**Lancaster County**  
**DEVELOPMENT REVIEW COMMITTEE**  
**April 26, 2016**  
**MINUTES**

Subject: Two Capital Partners

DRC 016- 013

**TWO Capital Indian Land  
Preliminary Site Plan submittal DRC Comments and responses**

## Address Slip

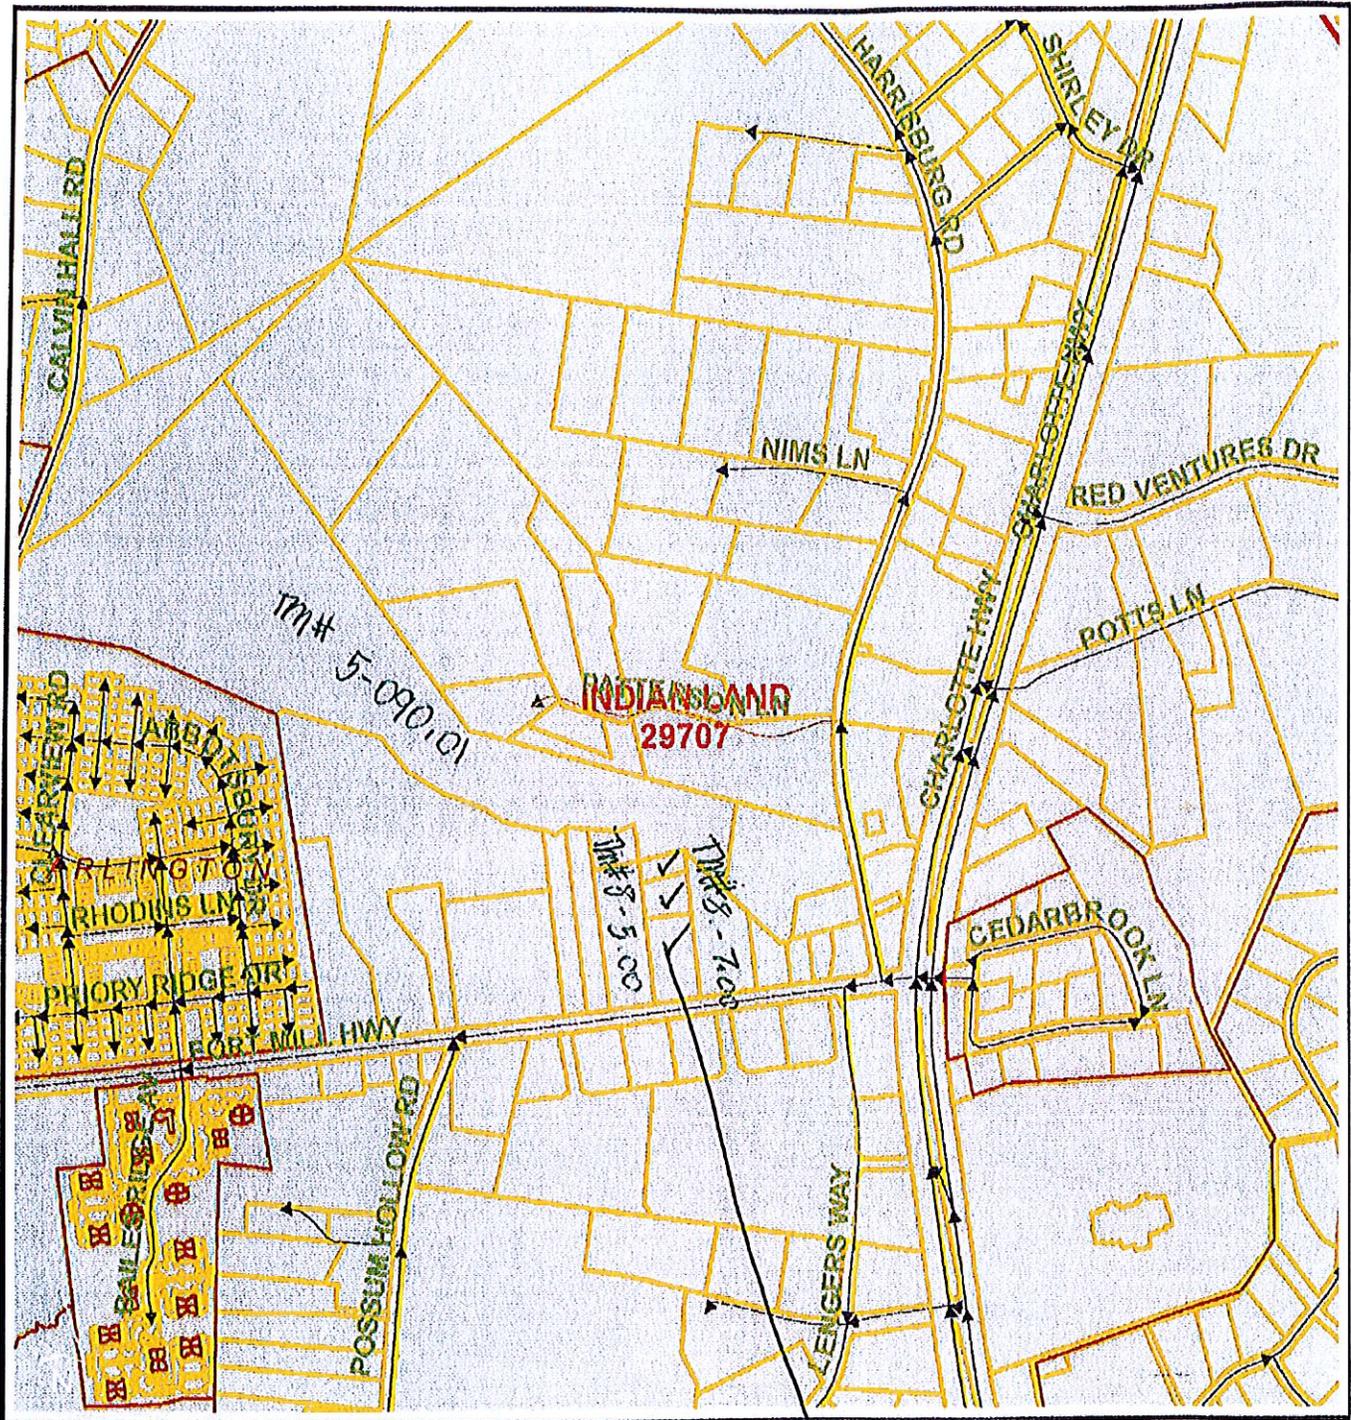
Will these parcels also be a part of the community?  
 Will this be the entrance location off Fort Mill Hwy?
